Docket Item #3
Development Special Use Permit #2009-0017
Alexandria Sanitation Authority – On Site Improvements

A request for a development special use permit, with site plan and modifications, to construct additional wastewater treatment facilities on the existing site and for an increase in building height to 38 feet for a new building.

DSUP #2009-0017

West Elevation of Proposed Centrate Pre-Treatment Building

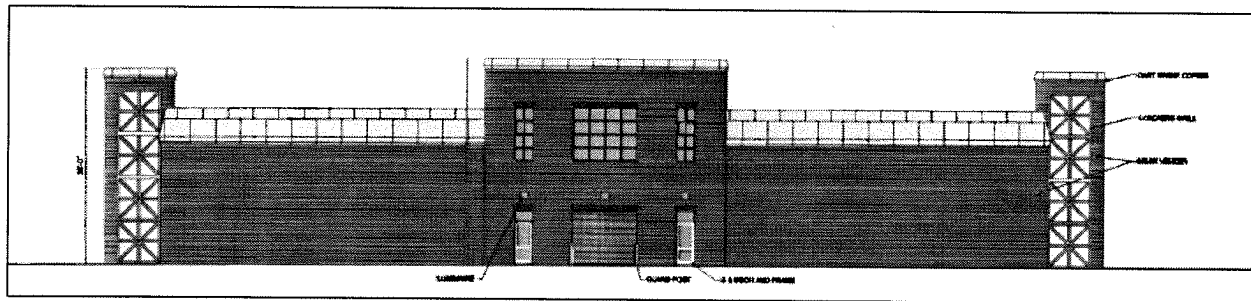
The UT/Utilities and Transportation zone permits heights up to 35 feet. Heights up to 50 feet may be allowed with a special use permit. The proposed CPT facility is 38 feet at the tallest point, thus triggering the need for a special use permit. The building is designed with parapet walls to screen the tanks that are part of the facility. Reducing the walls to the 35 foot height limit will reduce the screening for the facility. Staff supports the SUP request for an additional 3 feet of height since the amount is fairly minor, it contributes to the screening for the industrial use, and the design of the overall building is still consistent with the buildings on the remainder of the site.
